Date: March 15, 2018  
To: Cumberland Planning Board  
From: Carla Nixon, Town Planner  
Subject: OceanView at Cumberland - Major Subdivision Preliminary Plan Review

Date March 15, 2018  
To Town of Cumberland Planning Board  
From Carla Nixon, Town Planner  
Subject **Major (Preliminary) Subdivision Review: Oceanview @ Cumberland. 277 Tuttle Road**

As requested, Sevee & Maher Engineers, Inc. (SME) has completed a review of the comment responses submitted for the preliminary application for a Major Subdivision and Site Plan for the proposed OceanView at Cumberland senior living community located off Tuttle Road. This submission is identified by the applicant as Revised Preliminary Subdivision Plan Submittal – Addenda-1A. The application materials received by SME were prepared by LICHT Environmental Design, LLC (LICHT), and consist of the following:

PROGRESS PLAN  
NOT FOR CONSTRUCTION

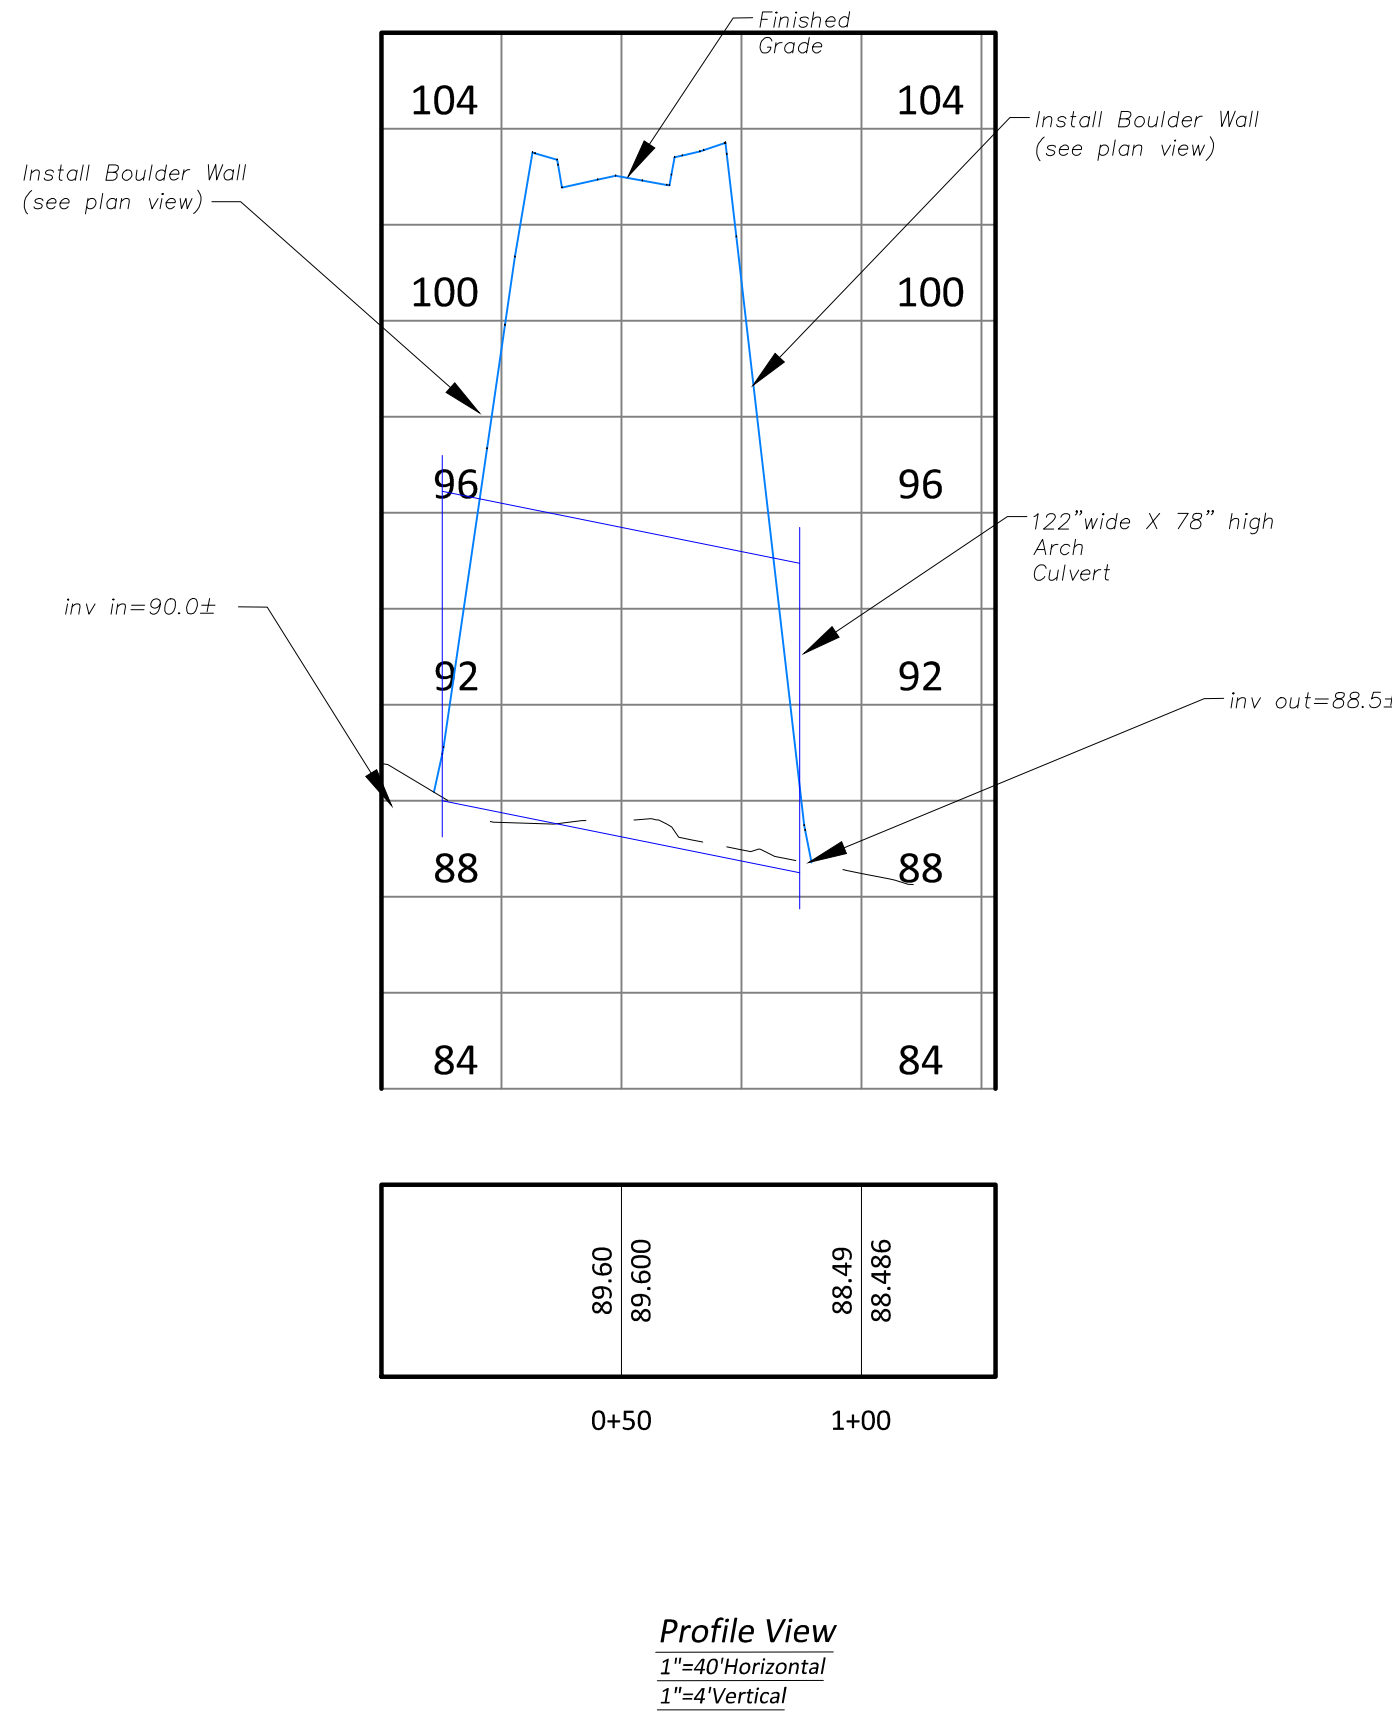
39. Arch 2 Culvert Details C21 - Profile does not include a sidewalk. SME recommends the applicant update the plan to reflect proposed construction.

39. Arch 2 Culvert Details C21 - Profile does not include a sidewalk. SME recommends the applicant update the plan to reflect proposed construction. *The culvert details and sizing have been revised (100 year storm design). It should be noted that final construction details will be provided for final plan submittal pending agency reviews.*
